PROPOSED RESIDENTIAL AND MIXED-USED DEVELOPMENT ON PORTION 11 OF FARM NR.1426, PAARL (AVEC LA TERRE) DEA&DP Reference: 16/3/3/6/7/2/B3/28/1396/22.

Reference is made to the Draft Scoping Report for the proposed residential and mixed used development of the abovementioned property.

Subject: DRAFT SCOPING REPORT: IN TERMS OF THE NATIONAL ENVIRONMENTAL MANAGEMENT ACT, 1998 (ACT NO. 107 OF 1998) AND THE ENVIRONMENTAL IMPACT ASSESSMENT REGULATIONS: PROPOSED RESIDENTIAL AND MIXED USE DEVELOPMENT ON PORTION 11 OF FARM 1426, PAARL

TITLE: PROPOSED SUBDIVISION, REZONING & PHASING PLAN

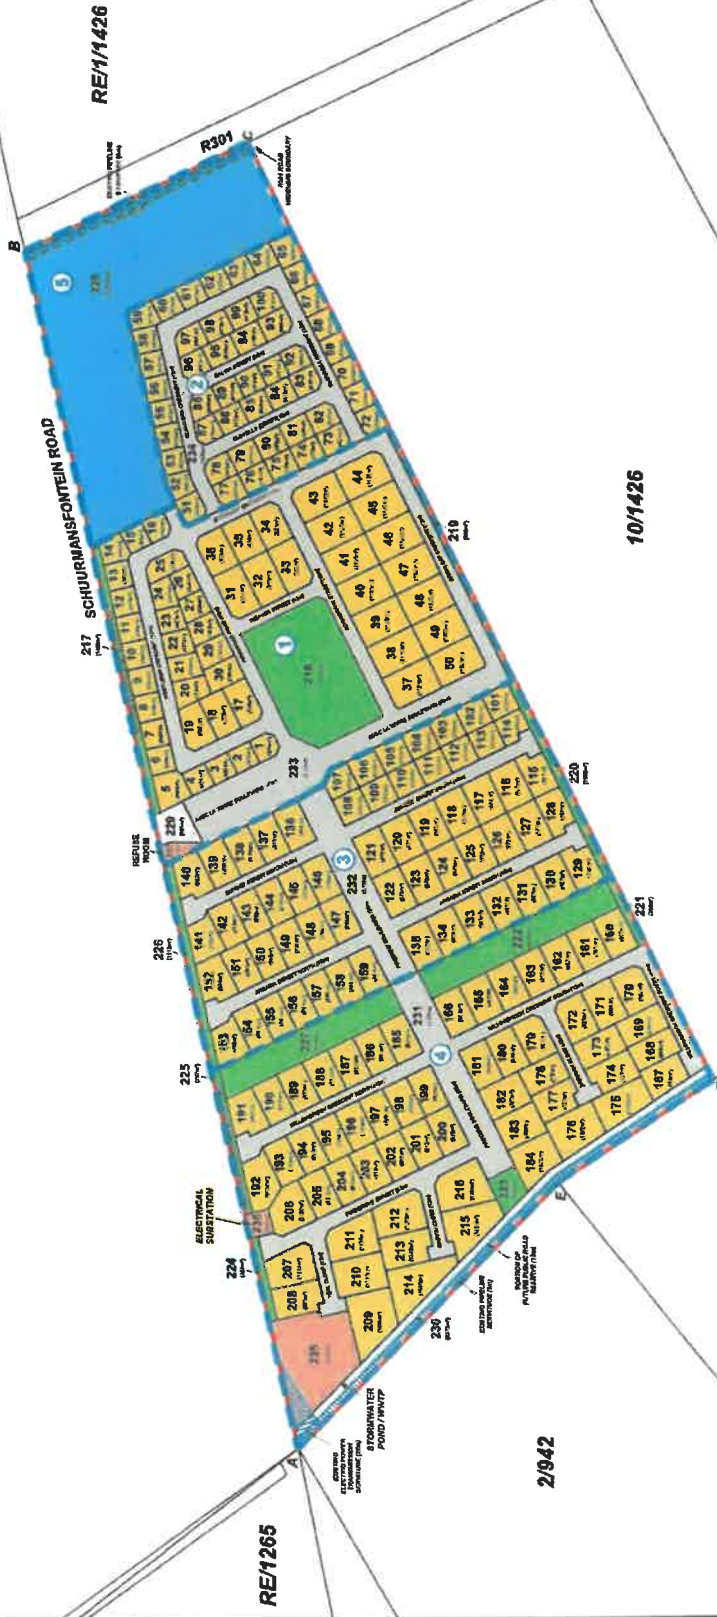
Kan jy asb dit verander in jou kapasiteit-brief, asook die substasie se afmetings na 20x20m.

- Aangeheg is die nuutste uitleg, wat ook die gewysigde posisie van die substasie aandui, soos tevore bespreek. Ons het die nuwe tekening bespreek in die tyd wat julle emails af was – ek het harde kopieë kom aflewer. Die posisie is geskuif weens die riool-pompstasie wat in die hoek van die ontwikkeling gebou word.
- Ons eerste bespreking was 20x20m vir die substasie. Dis hoe die planne ook gedoen was. Kan ons asb dit so hou?
- Kan ons die bestaande 11kV-lyn ondergronds skuif – ontwikkelaar se onkoste?
- Kan ons die Eskom NMD-kostes bespreek in ons vergadering.

Drakenstein Municipality confirm that there is sufficient power available at our main intake 66/11kV Dwarsrivier substation. The availability however on the 11kV network require upgrading in order to ensure the required load of 2 326kVA to the development. A new proposed 11kV switching station (20mx20m) will have to be constructed at a suitable location with twenty-four-hour access, closest to Schuumansfontein Road, across Pearl Valley entrance adjacent to The Acres development, to accommodate for the upgrading of the existing 11kV reticulation. The proposed 11kV switching station will feed directly from the existing 66/11kV Dwarsrivier substation. It must however be noted that two additional feeder cables must be installed from the existing 66/11kV Dwarsrivier substation, as well as the extension of the existing feeder cables to the new proposed 11kV switching station. The previous mentioned further require for the construction and installation of additional switchgear within the existing 66/11kV Dwarsrivier substation.

The existing 11kV reticulation will have to change as such, that Pearl Valley and The Acres ring feeds shall feed separately from the new proposed 11kV switching station. The new proposed development shall be interconnected to form part of the The Acres ring feed. Service servitudes will also have to be included in the layout of the development plans, which can only be indicated after the final position of the proposed 11kV switching station has been confirmed.
